RESPONSES TO NRC REQUESTS
DATED APRIL 22, 1977, FOR ADDITIONAL
INFORMATION REGARDING THE PROPOSED COOLING
SYSTEM DESIGN CHANGE

DOCKET NO. 50-410

NINE MILE POINT NUCLEAR STATION - UNIT 2
NIAGARA MOHAWK POWER CORPORATION

SEPTEMBER 30, 1977

FIGURE R4-2
 AVERAGE ANNUAL
 WATER DEPOSITION
 (LBS/ACRE/YR)
 NINE MILE POINT NUCLEAR STATION-UNIT 2
 NIAGARA MOHAWK POWER CORPORATION

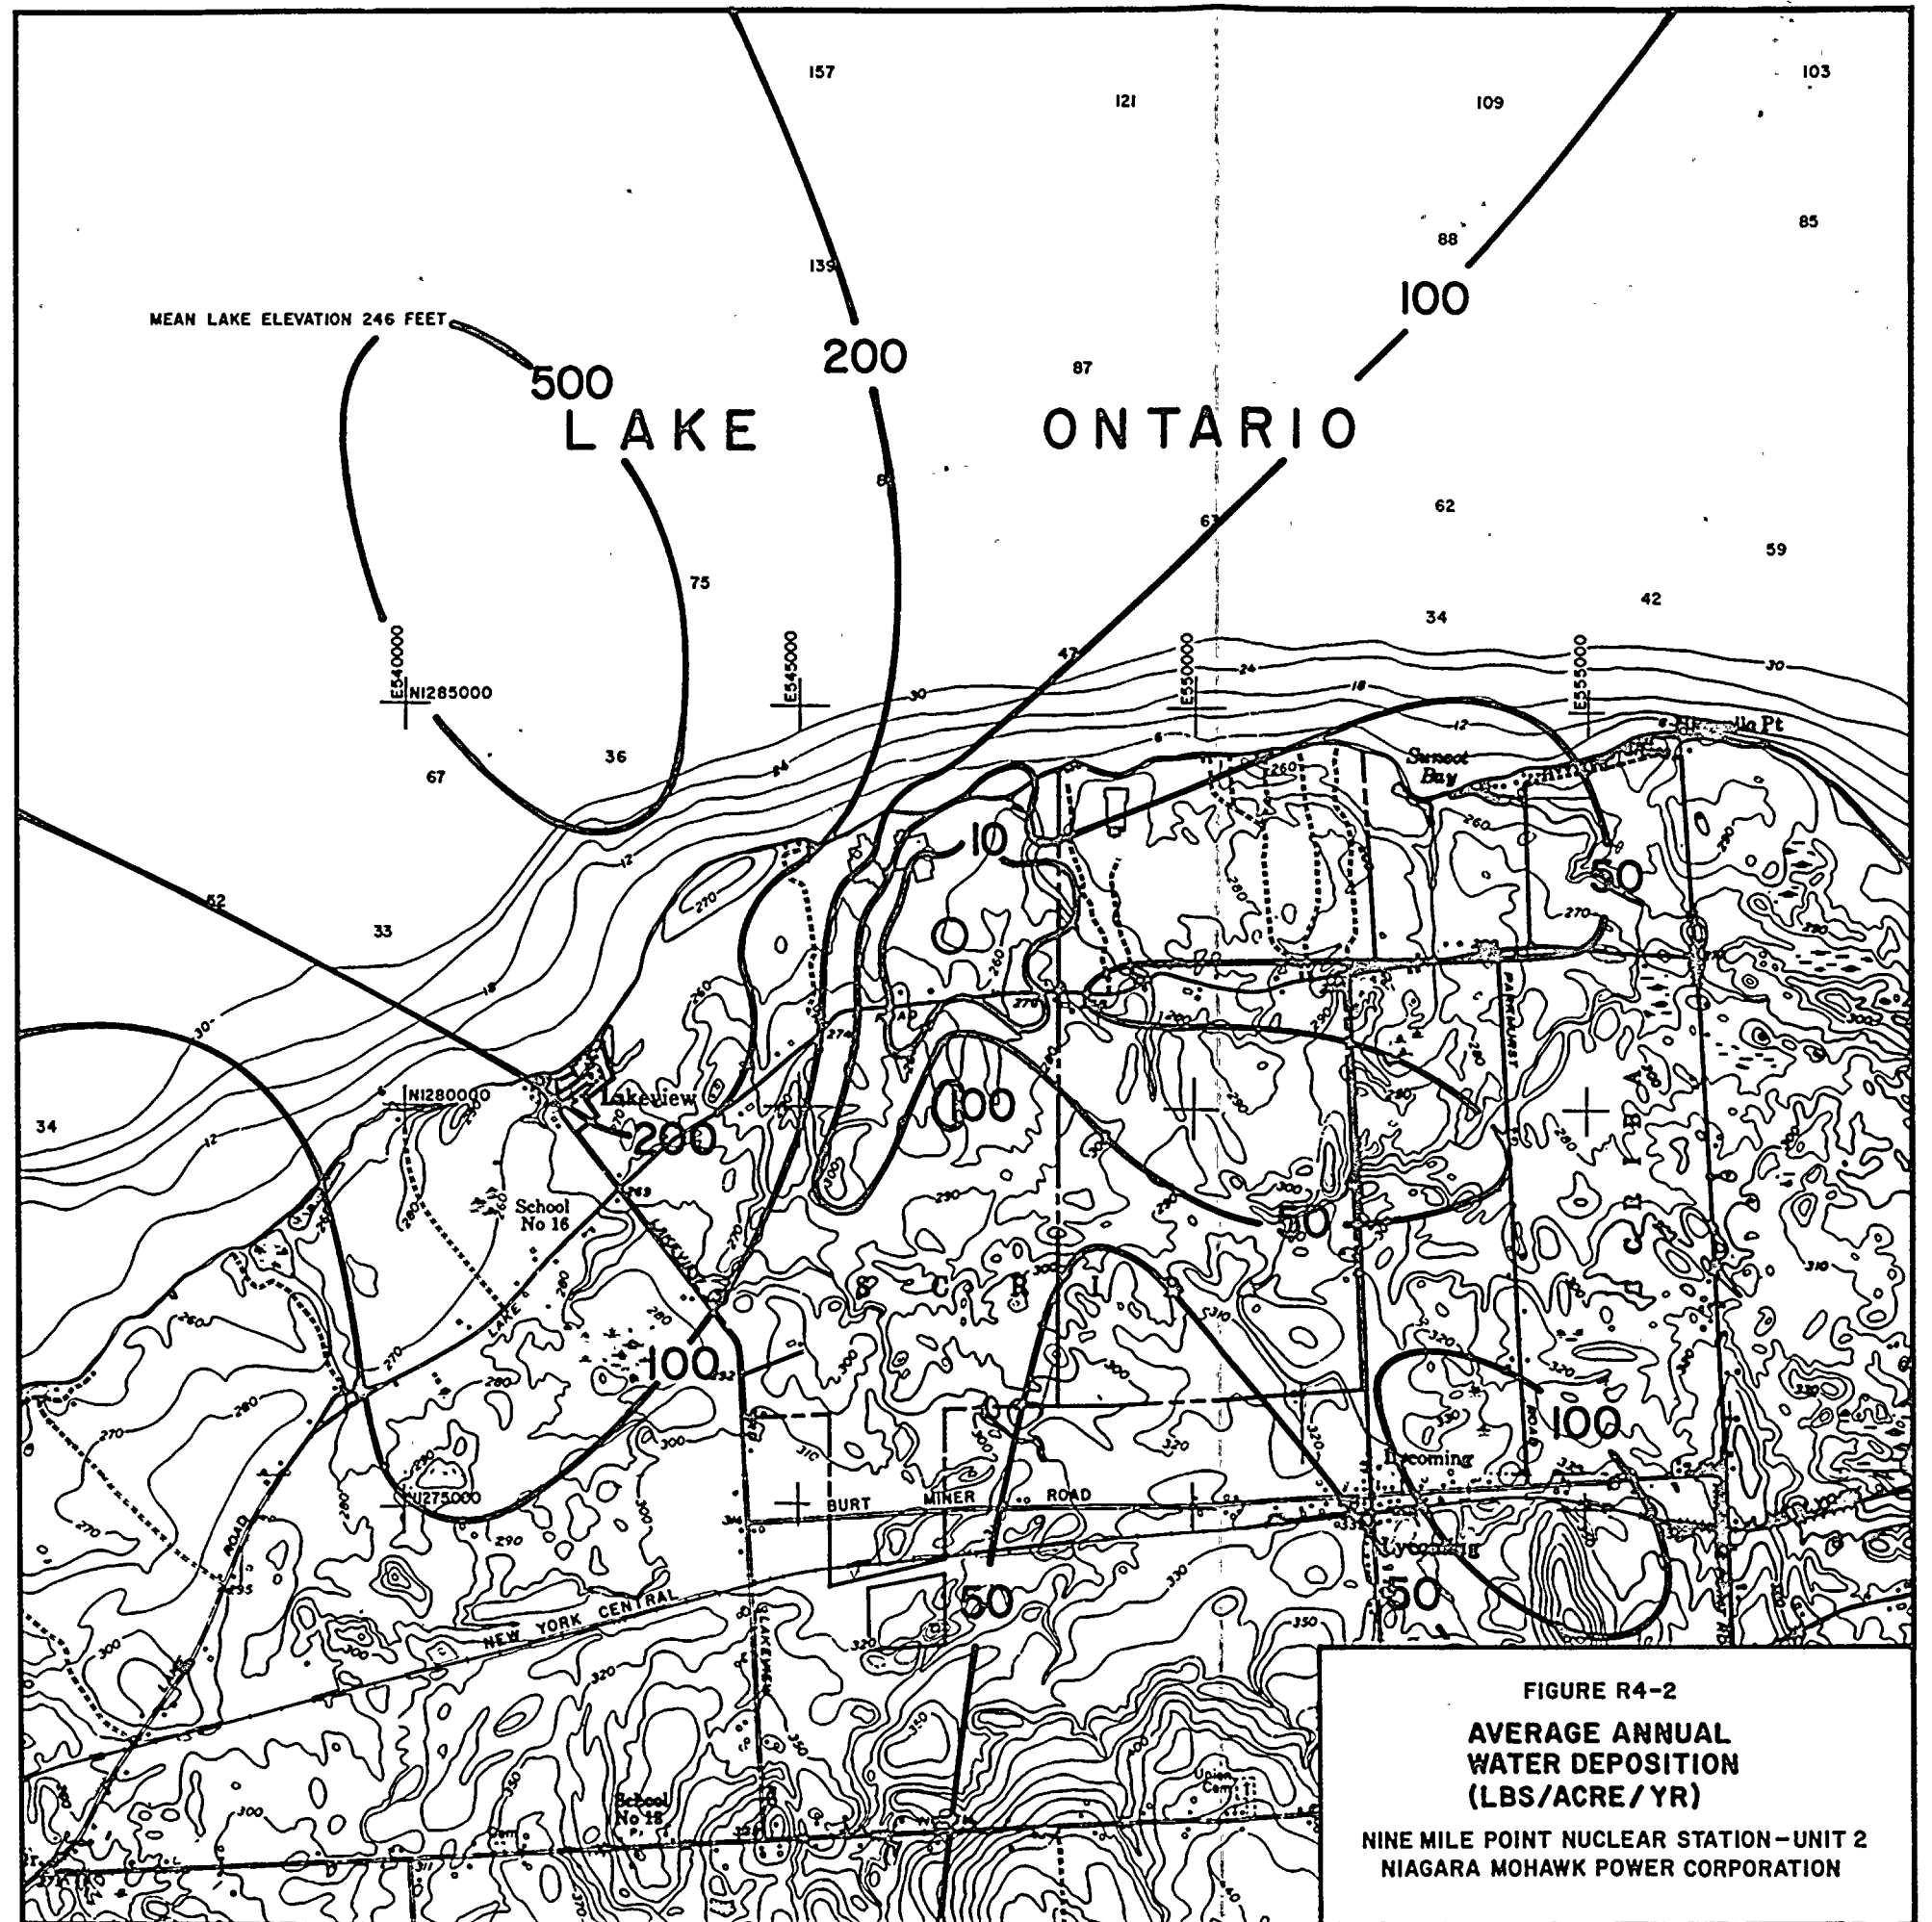
In addition to Figures 5 and 6, Water and Salt Drift for an Annual Period, provide figures showing water and salt drift amounts for each month or season of the year.

Average annual salt deposition rates in lbs/acre/year are shown in Figure 4-1. The maximum salt deposition rate was predicted to be 0.27 lbs/acre/year, 6750 feet northwest of the tower. Figure 4-2 presents annual water deposition rates in lbs/acre/year with maximum value of 690.6 lbs/acre/year occurring 6750 feet northwest of the tower. This amount of water corresponds to 0.0030 inches of water per year.

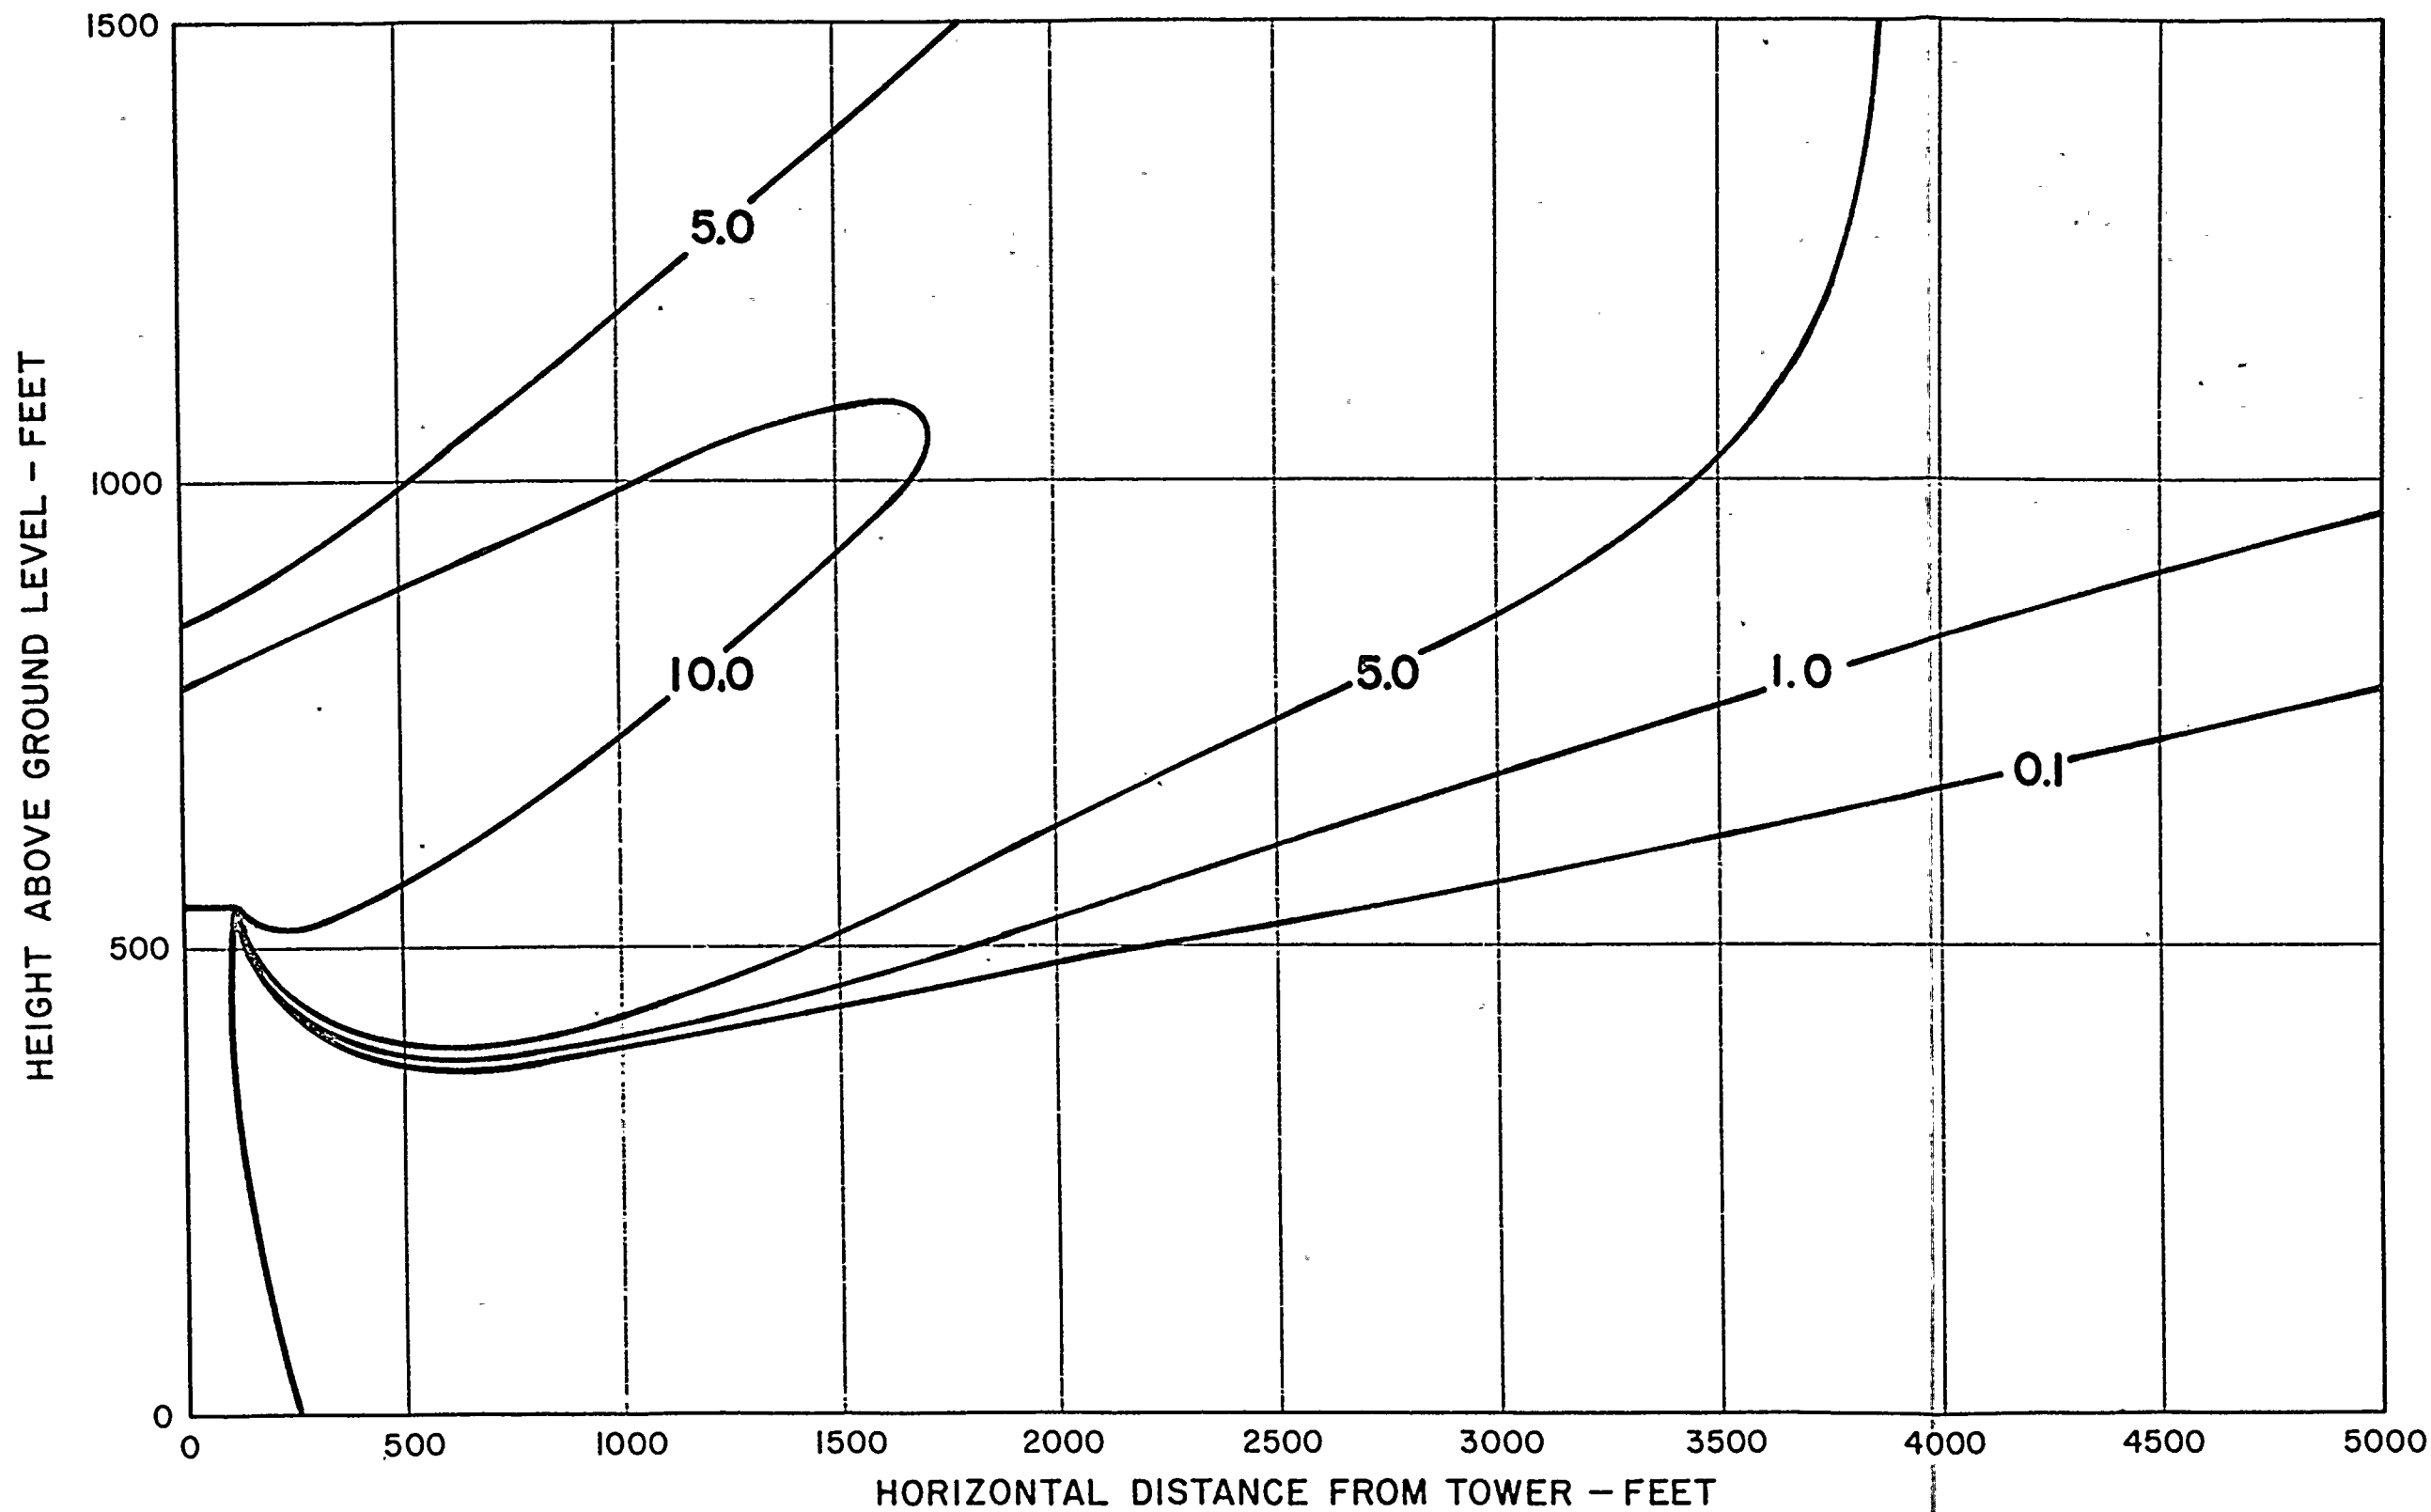
In addition to Figures 8 through 12, Predicted Annual Plume Lengths, provide figures showing monthly or seasonal elevated plume lengths.

The visible plume model used to produce Figures 8 to 12 was run with revised cooling tower characteristics described in Request 1 and three years of onsite meteorological data from January 1, 1974, to December 31, 1976.

Figures 7-1 through 7-25 provide the percent of time that a visible plume is predicted to occur within 5000 feet of the natural draft cooling tower for each wind direction quadrant and for all wind directions combined for each season of the year and for the entire year. These contours do not represent individual plume outlines, but the combination of many individual plumes, in order to show the maximum vertical and horizontal extent of the visible plume for each given frequency of occurrence.
